CEDAR KEY WATER AND SEWER DISTRICT
INVITATION TO BID NO: 2024-02
SANITARY SEWER LIFT STATION REHABILITATION
ADDENDUM NO. 1

April 22, 2024

The following changes have been made to the plans & specifications for the above project:

C-103

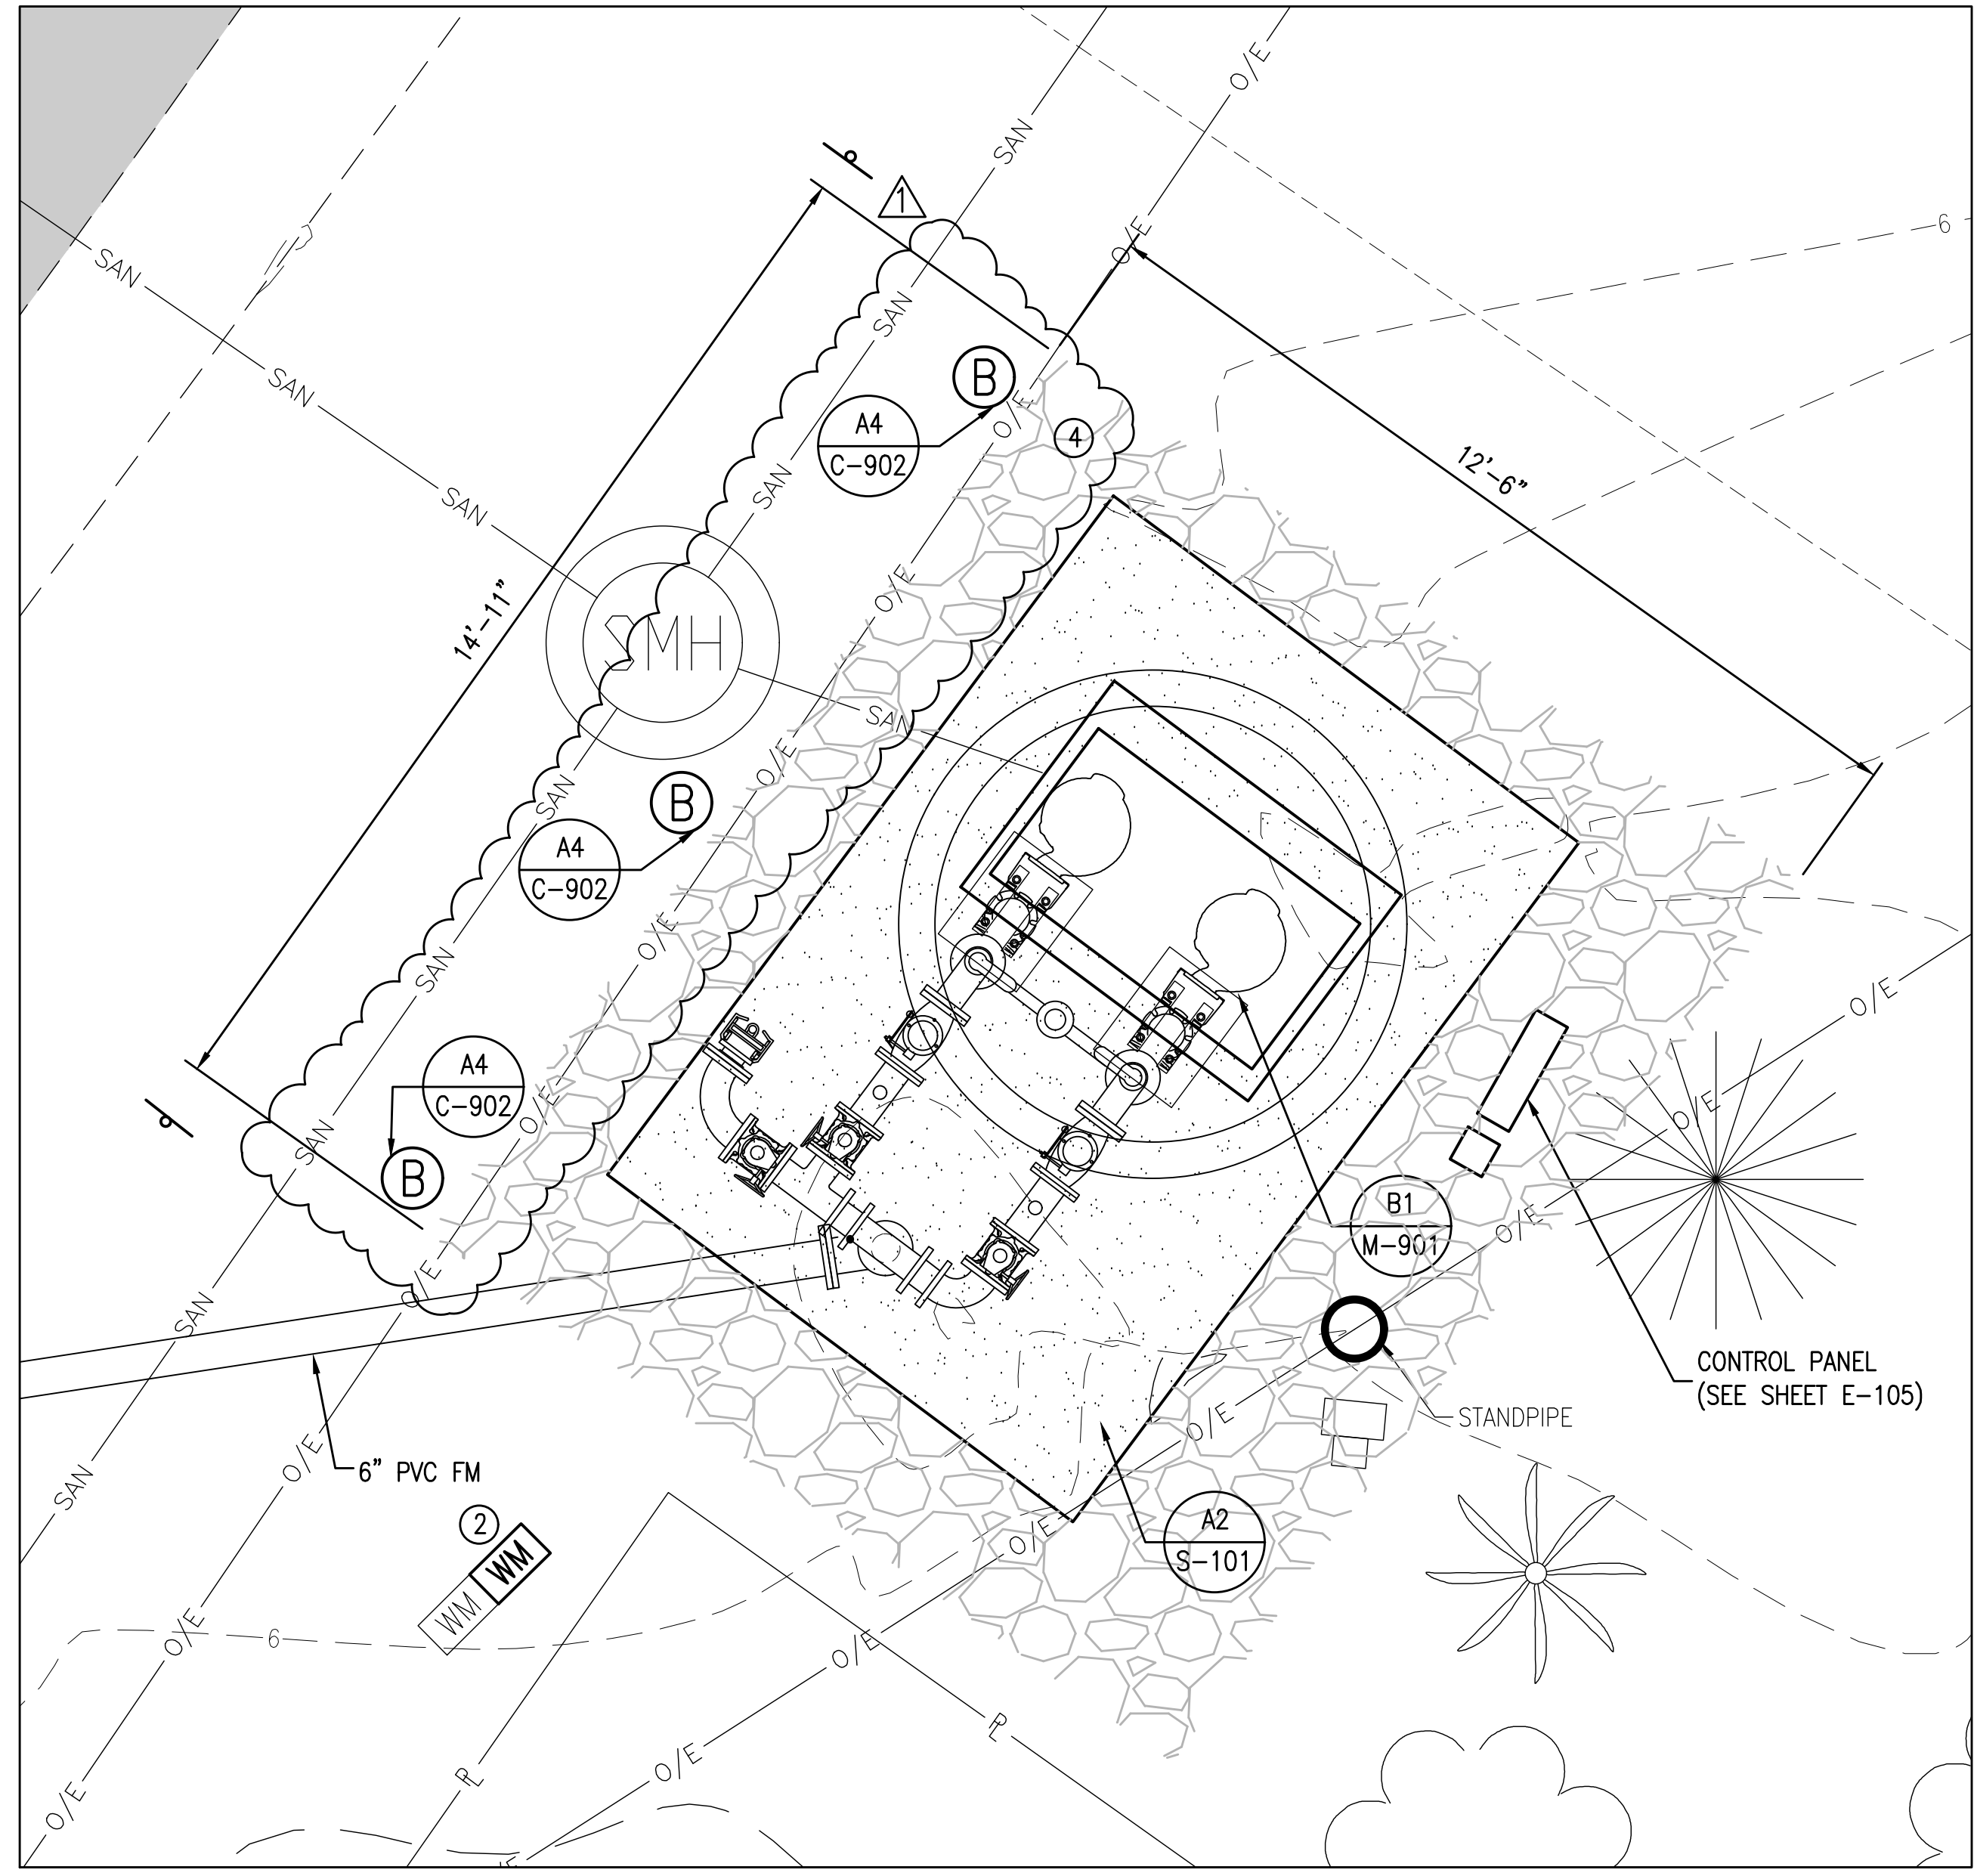
SHEET NO.	CHANGE
C-103	Updated drawing to include three (3) Removable Traffic Rated Bollard. The proposed fence was removed and the proposed gravel for the site was updated accordingly. The Contractor is required to install an emergency contact sign at the Lift Station 6 site.
C-104	Updated drawing to include a Demolition Hatch for the removal of the Existing Air Vent
C-105	Updated drawing to include 4” SS Air Vent to Lift Station 7
C-900	Updated drawing to include an Emergency Contact sign that shall be placed at each lift station site. The Contractor is required to install the emergency contact sign and support pole at the Lift Station 6 site.
C-902	Updated drawing to include Removable Locking Bollards Detail
M-901	Updated drawing to include the correct pump HP requirements and updated the Emergency Shutoff Level
M-902	Updated drawing to include 4” SS Air Vent to the Lift Station 7 Detail and Updated the Emergency Shutoff Level

- Q. The plans show a new fence around Lift Station #6, however there is not a line item for new fence at Lift Station #6 on the bid sheet.
- A. The updated Lift Station #6 drawings were updated accordingly. The proposed Lift Station #6 site fencing was replaced with traffic rated removable bollards. The bid tab was updated accordingly to reflect these changes.

1. Remove the fence from the FDOT Right of Way.
 - a. The fence was removed from FDOT right of way on the Lift Station 6 site
2. All items 4-inches high or higher within the clear zone must be shielded.
 - a. For Lift Station 6, three (3) removable traffic bollards, rated for 40 mph (M40-P2), were placed as close to the right of way line as possible while still shielding Lift Station 6 piping and valves.

A1 CHAIN LINK FENCE DETAIL
NOT TO SCALE

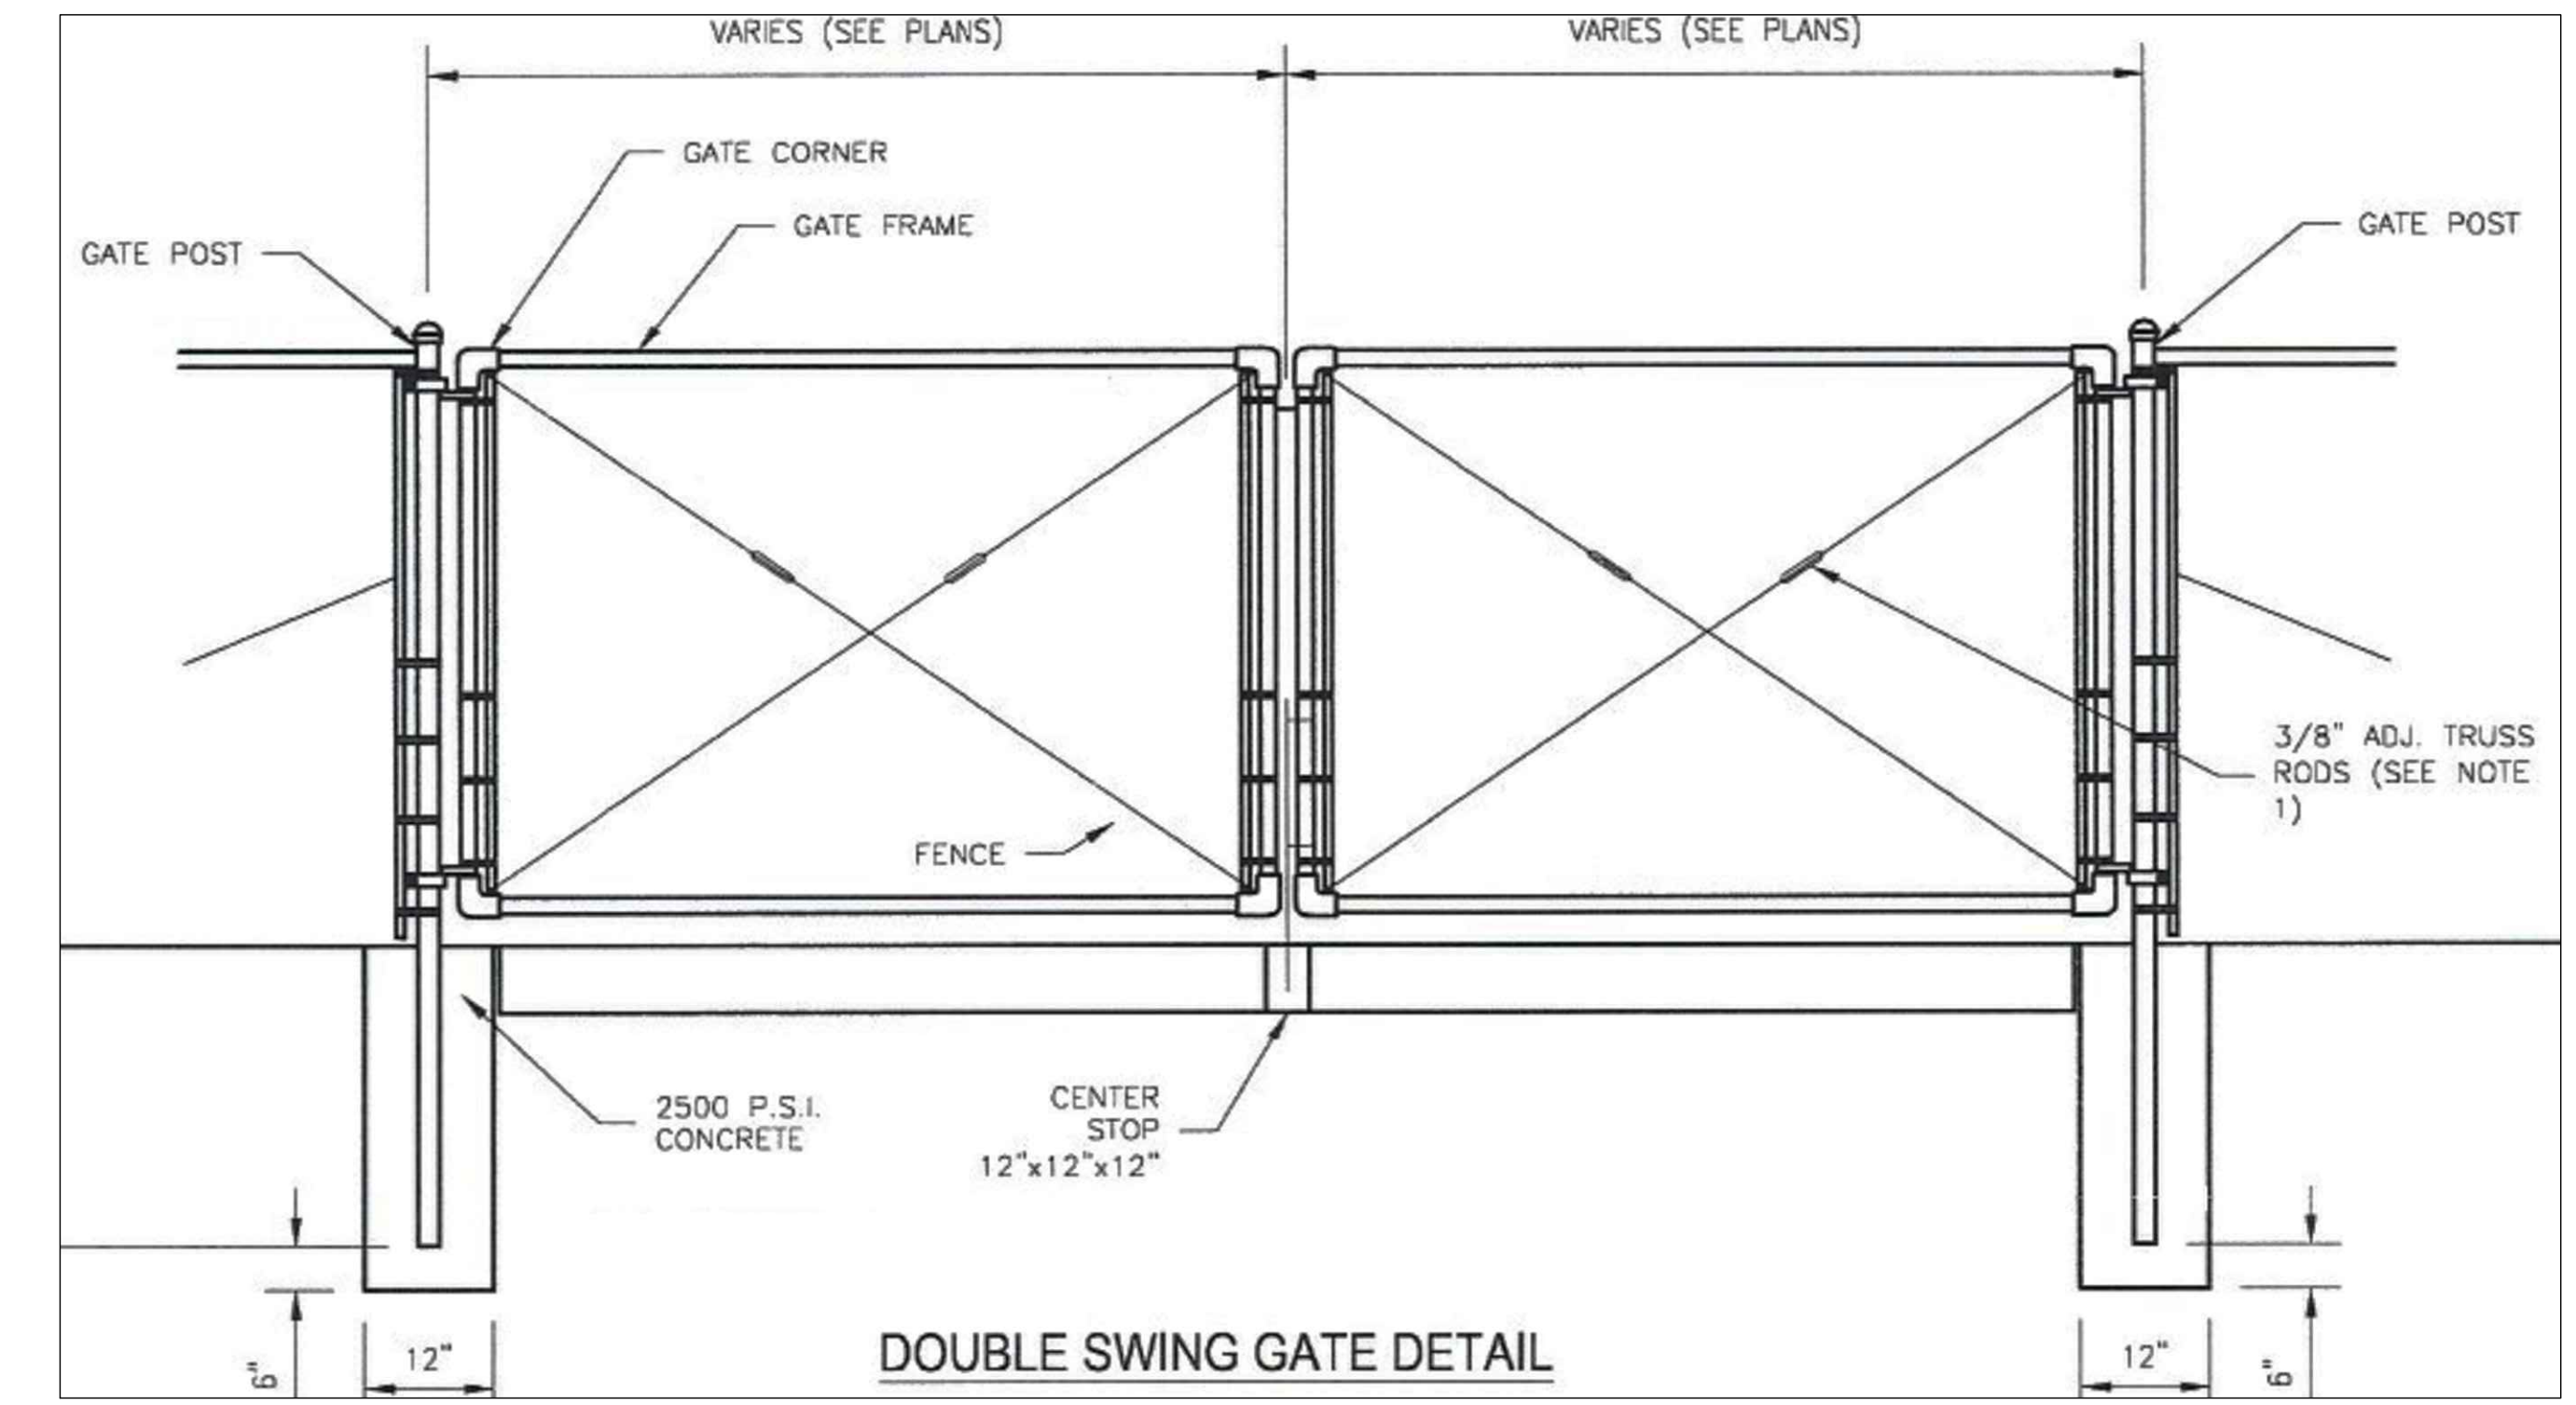
ITEM	DOCUMENT	CHANGE
1.	Specifications	Added attachment A (FDOT Utility Permit) to specifications.
2.	Bid Tab – Basis of Bid	Update Line item 2.11 to show (3) 4” plug valves instead of (2) 4” plug valves.
3.	32 31 13 – Chain Link Fence and Gates	Part 2 – Products was updated accordingly.

- Q. Can you please provide clarification on the new fences? According to our fence sub, the 3-1/2”x5” mesh cannot be ordered. Also, the fittings for the 2.375” top rail cannot be ordered.

1. Fabric Diameter & Finish: As indicated on Drawing sheet C-900, Detail A1.
 - a. No. 9 gauge core (0.148" + 0.005") size steel wires, 2-inch mesh, with top and bottom selvages with a minimum breaking strength of 1290 pounds. Furnish one-piece fabric widths for fencing up to 12-inches high. Fabric undercoat shall not be less than 0.30 ounces of zinc per square foot of surface.
2. Fabric Color: Minimum 7 mil polyvinyl chloride (PVC) plastic resin thermal fusion bonded finish over galvanized steel wire. Color shall be Manufacturer's standard black color selection.
